LiDAR Quality Assessment Report

VA-Louisa-LiDAR

VA_LouisaCo_2012

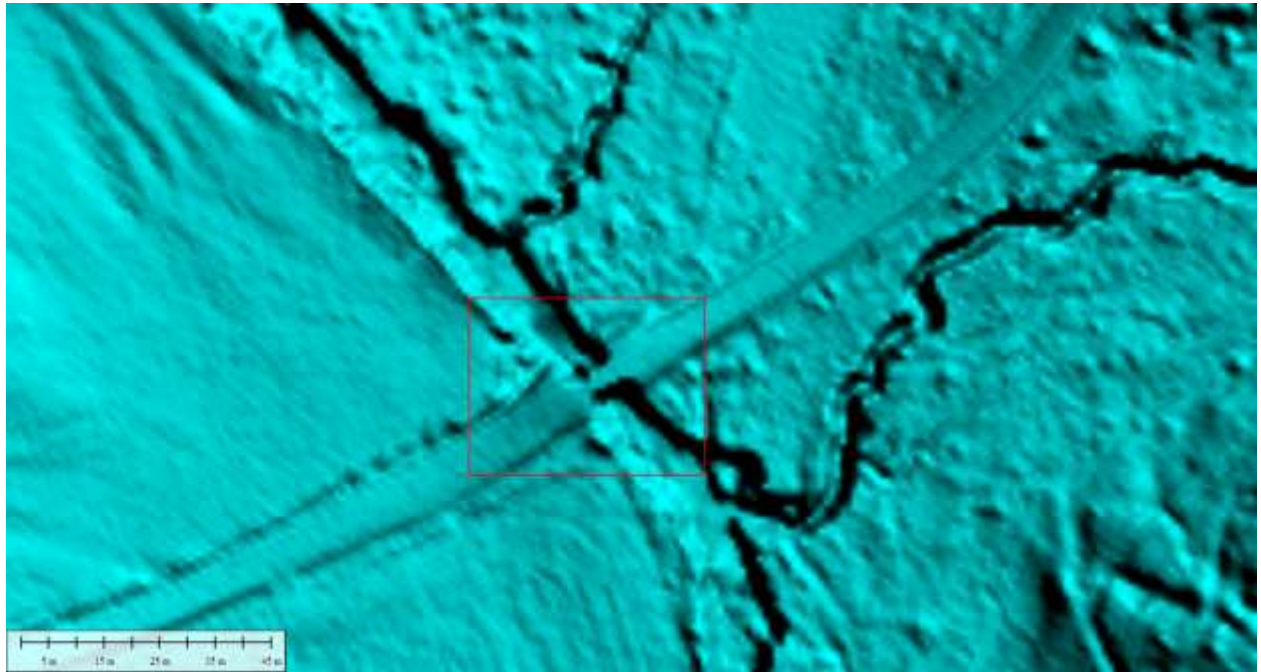
bridge_1: Ancillary data suggests this object is a bridge and not a culvert; vendor had attempted to remove it, however, NGTOC personnel completely removed it (...in the DEM, not the LAS).

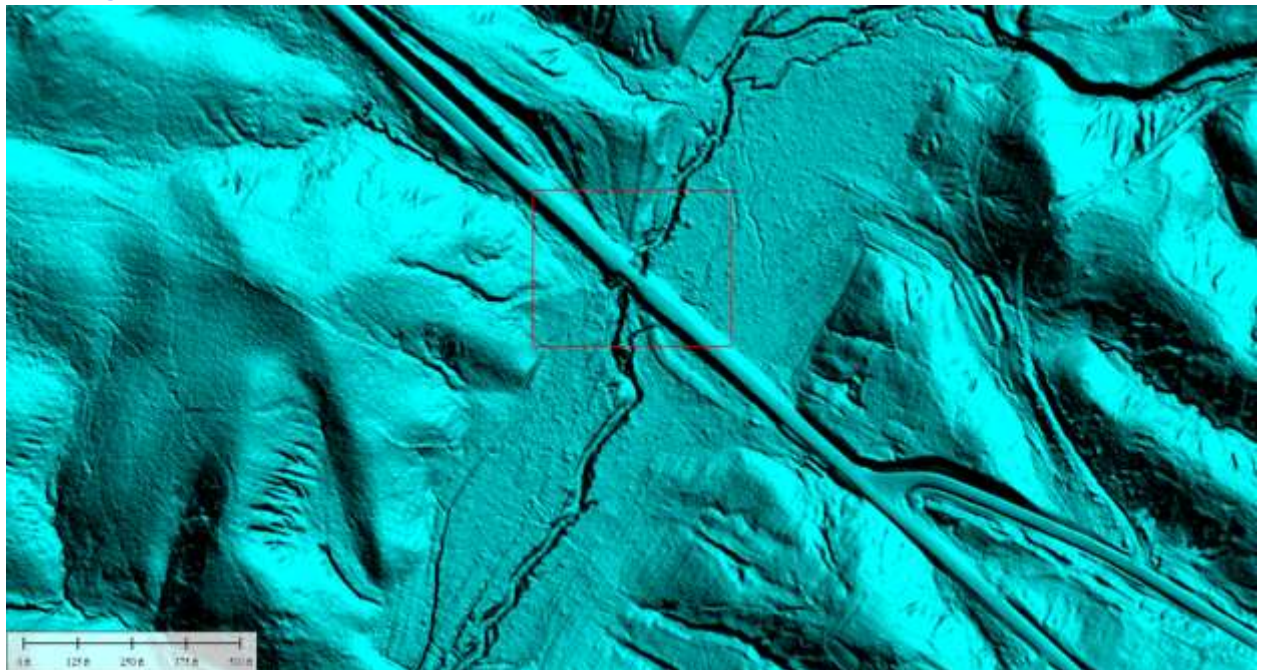
bridge_2: Ancillary data suggests this object is a bridge and not a culvert; vendor had attempted to remove it, however, NGTOC personnel completely removed it (...in the DEM, not the LAS).

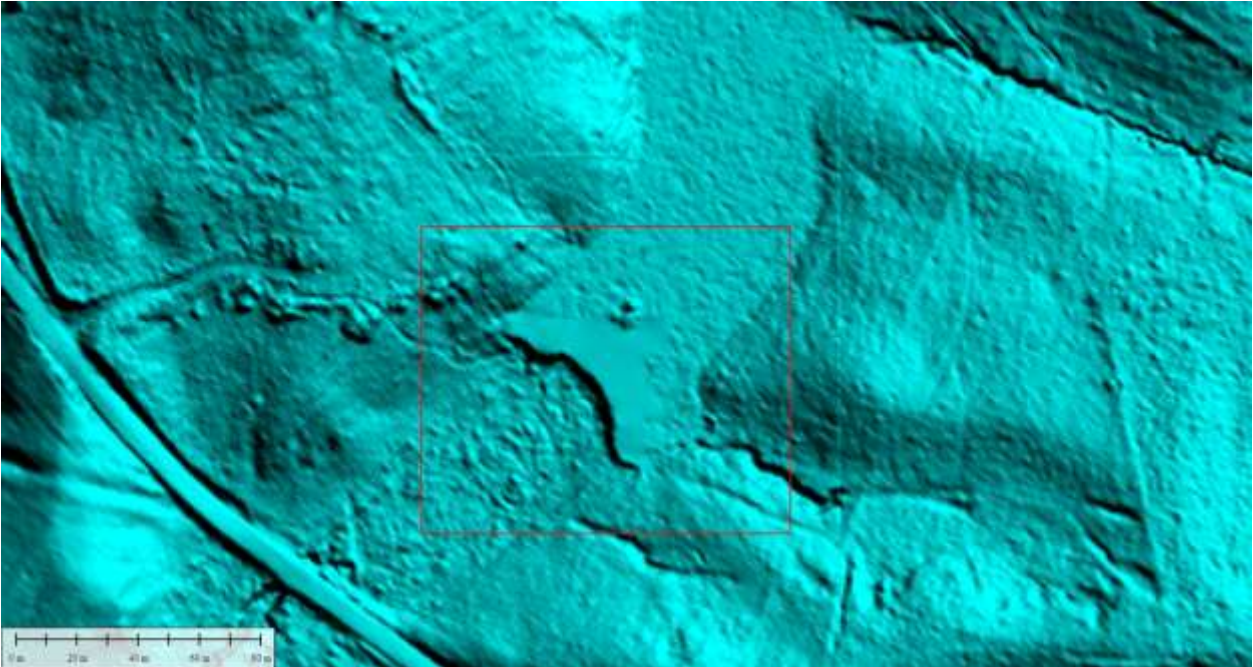
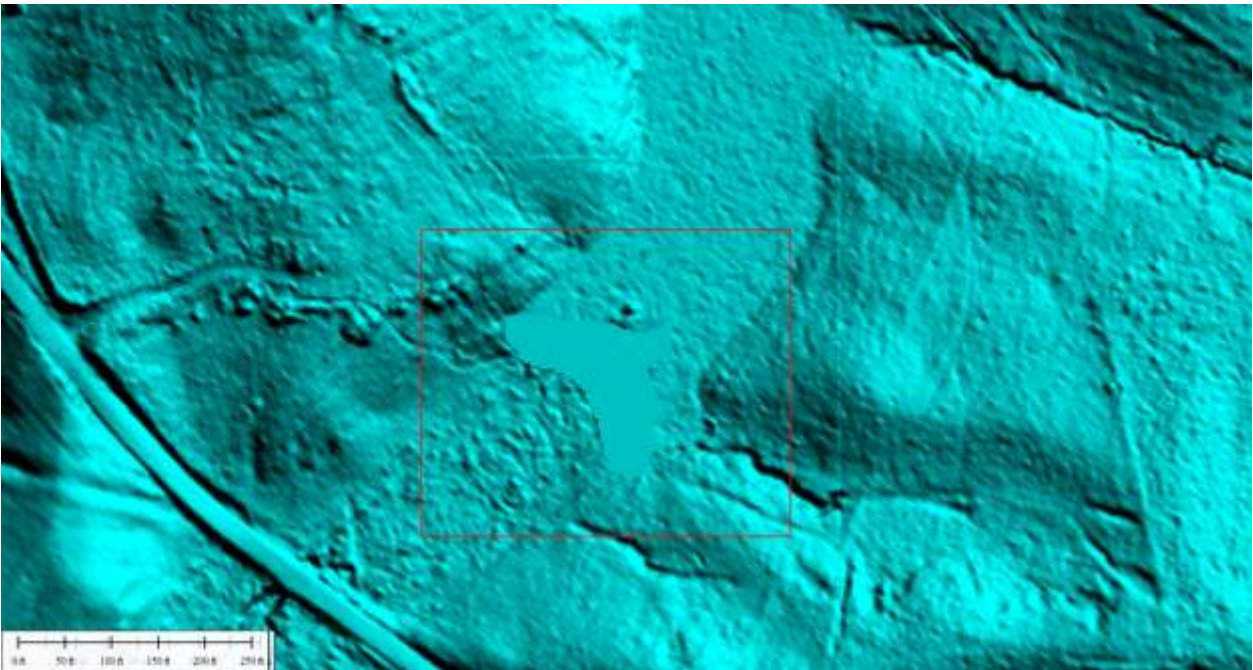
high_water_1: This portion of a stream is TIN'd and resulted in higher elevations than the rest of it. NGTOC personnel flattened/feathered this portion; see image below for results.

high_water_1_after: Portion of stream (see above image) that has been flattened/feathered; resulting elevations are more representative of surrounding channel.

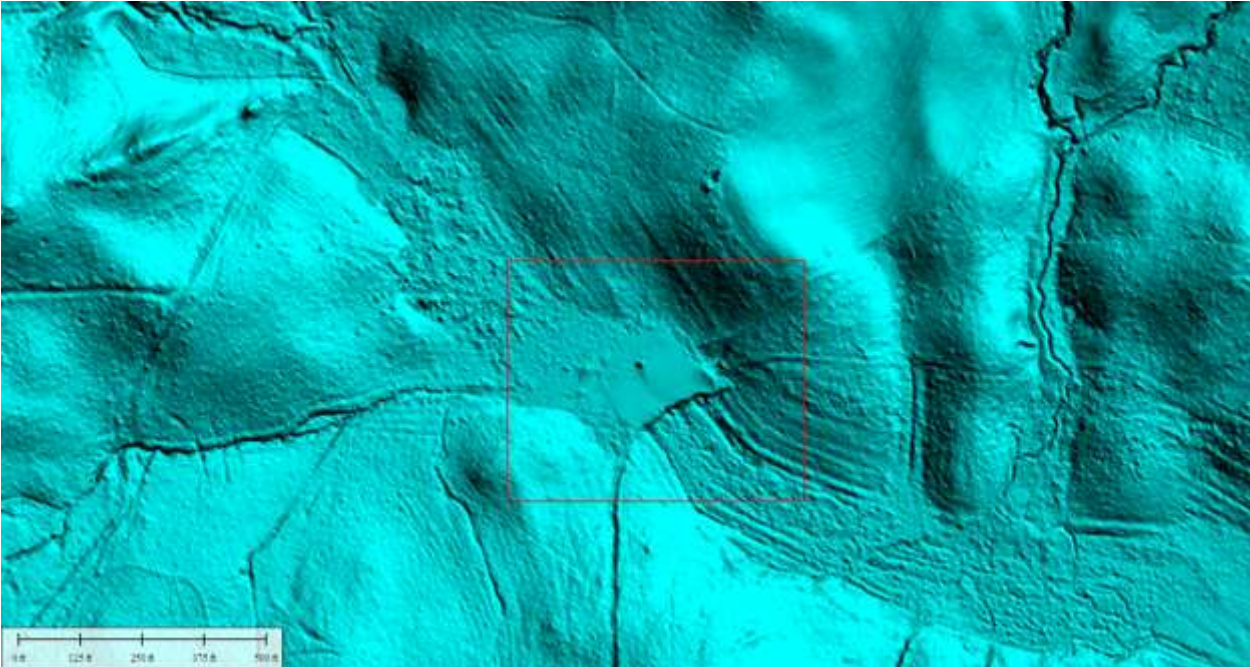
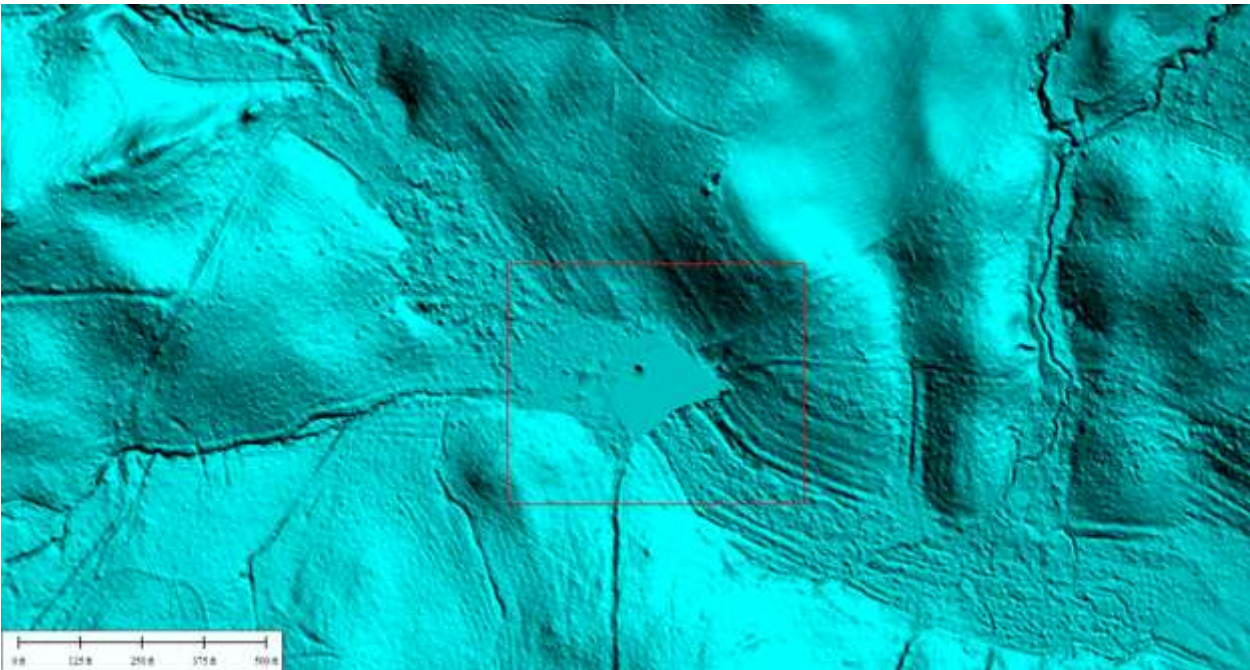
high_water_2: This portion of ponded water is TIN'd and resulted in higher elevations than the surrounding area. NGTOC personnel flattened/feathered this portion; see image below for results.

high_water_2_after: Portion of ponded water (see image above) that has been flattened/feathered; resulting elevations are more representative of surrounding area.

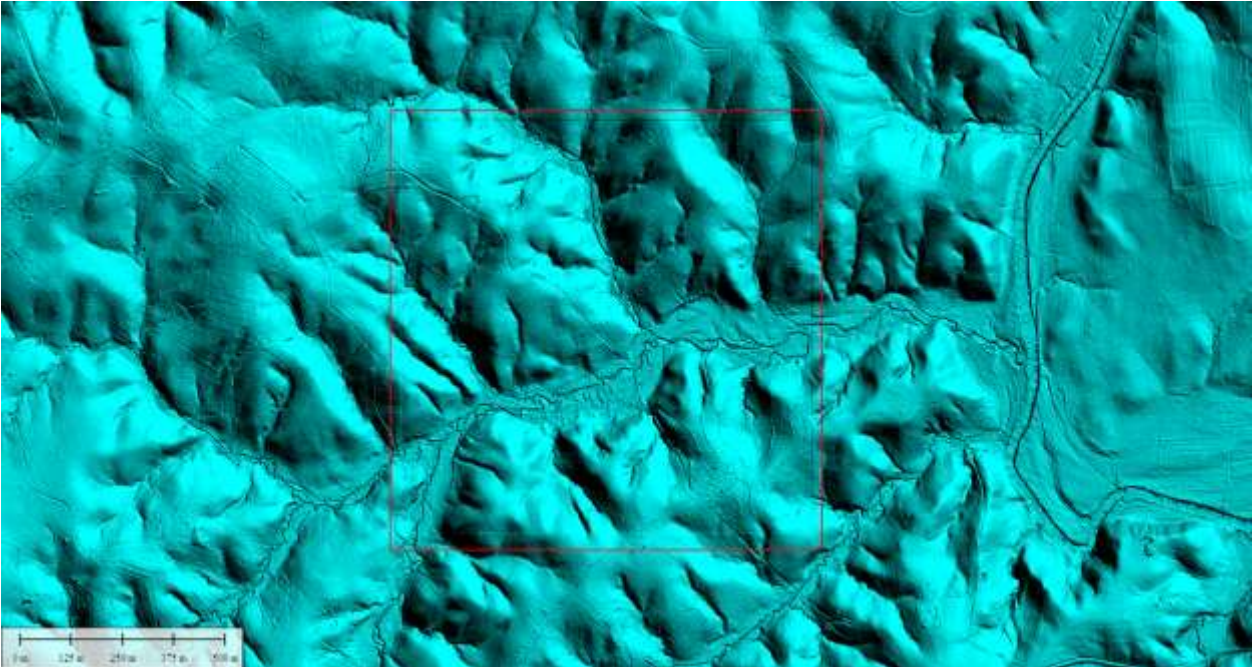
tile_outline: This image highlights a DEM tile that is bounded by a ridge. Please see remarks by Dewberry (vendor) with regards to this feature. The explanation is found in the Final Project Report (PDF) on page 44.
